**STAFF REPORT 06-26-2019 MEETING****PREPARED BY: A. PHILLIPS****APPLICATION NUMBER: 19-6283****ADDRESS: 1258 WASHINGTON BOULEVARD****HISTORIC DISTRICT: WASHINGTON BOULEVARD****APPLICANT: JAMES FLORA, DETROIT BEER EXCHANGE LLC****PROPOSAL**

With the current proposal, the applicant is seeking the Commission's approval to complete the following work associated with the overall rehabilitation of the building, specifically a tenant build-out for a restaurant at the basement and first level of the existing building. Although Resolution 19-01 allows HDC staff to approve exterior wall penetrations for the installation of ventilation/mechanical, electrical, or plumbing utilities at the side and rear elevations, staff is *unable* to approve the addition of rooftop mechanical units. See attached drawings for locations of the following proposed work items:

PARTIAL BLDG SECTION B-B'  
(BETWEEN COL 2 & 3)

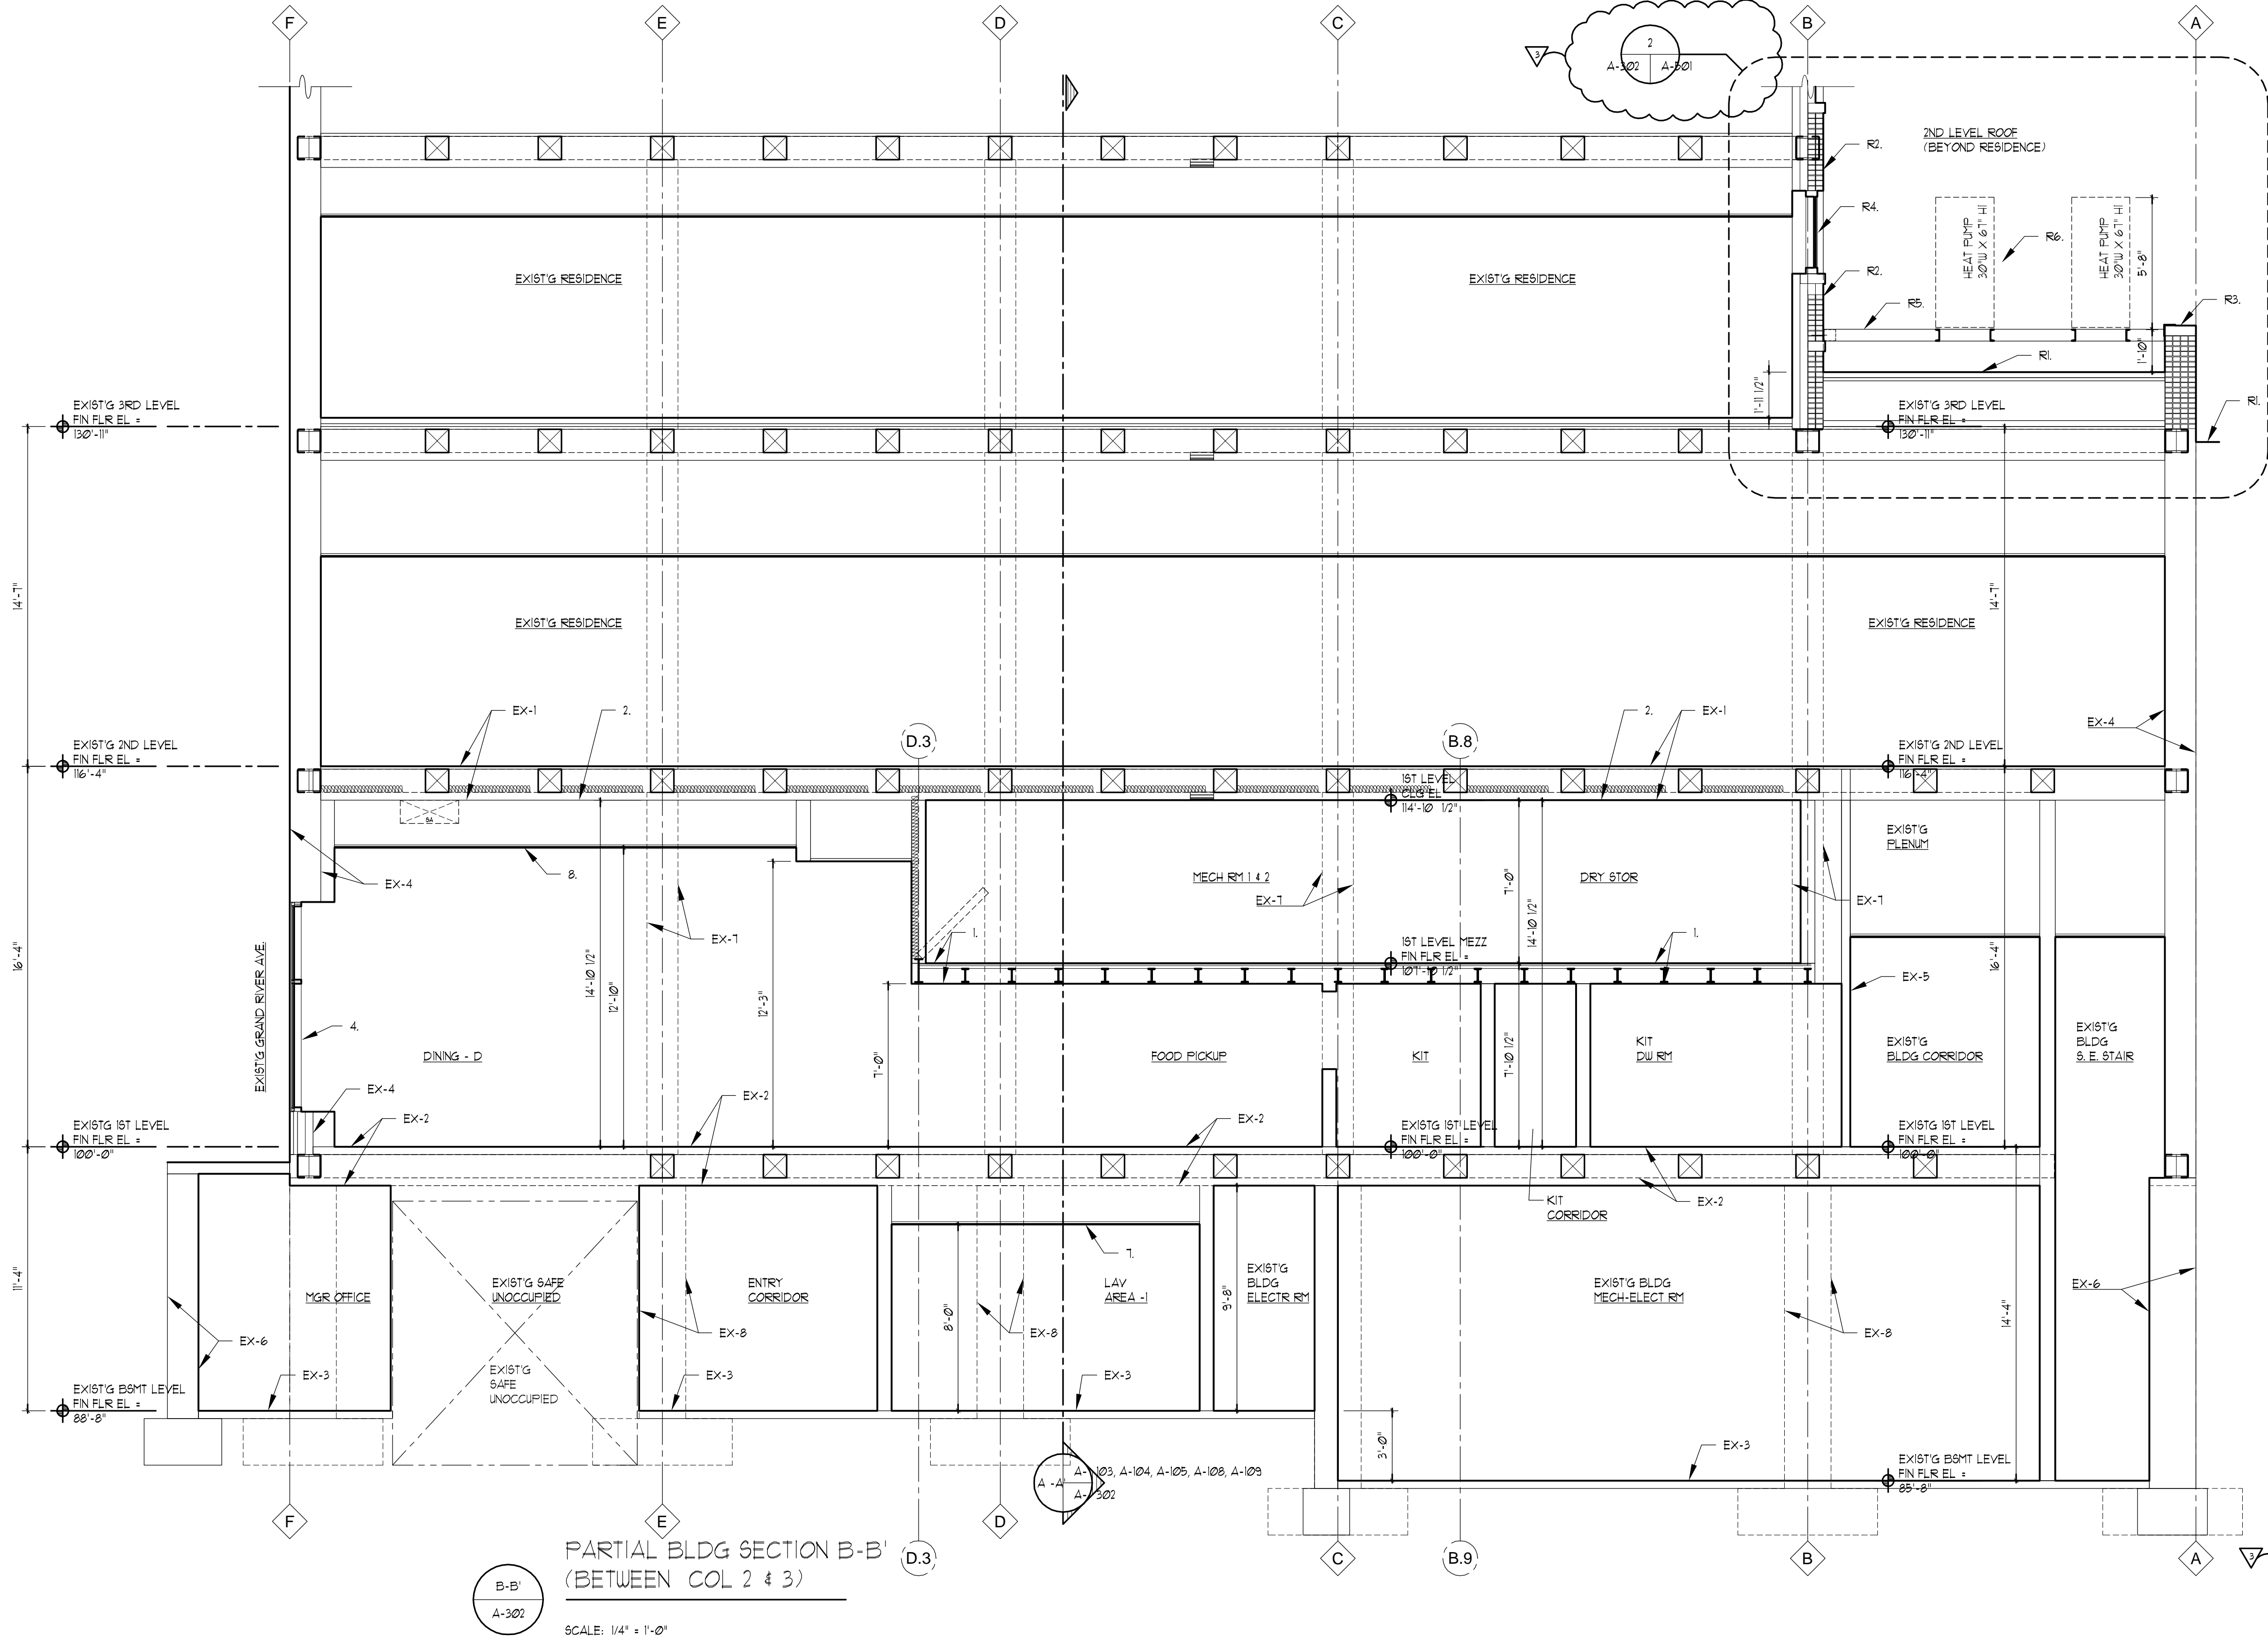
- Installation of (2) new mechanical rooftop units on the existing 2<sup>nd</sup> floor roof. The second floor roof is located at the southeast corner of the building and faces the alley located adjacent to the building on the east side (see attached photos and drawings).
- Installation of (2) wall-mounted air intake ductwork on the east (alley side) façade.
- Installation of (2) exhaust grilles and (1) wall-mounted fan at various locations on east (alley side) façade (see attached drawings for locations).

Staff recommends that the Commission find the project scope, as proposed, to be appropriate as it meets the following Secretary of the Interior's Standards for Rehabilitation
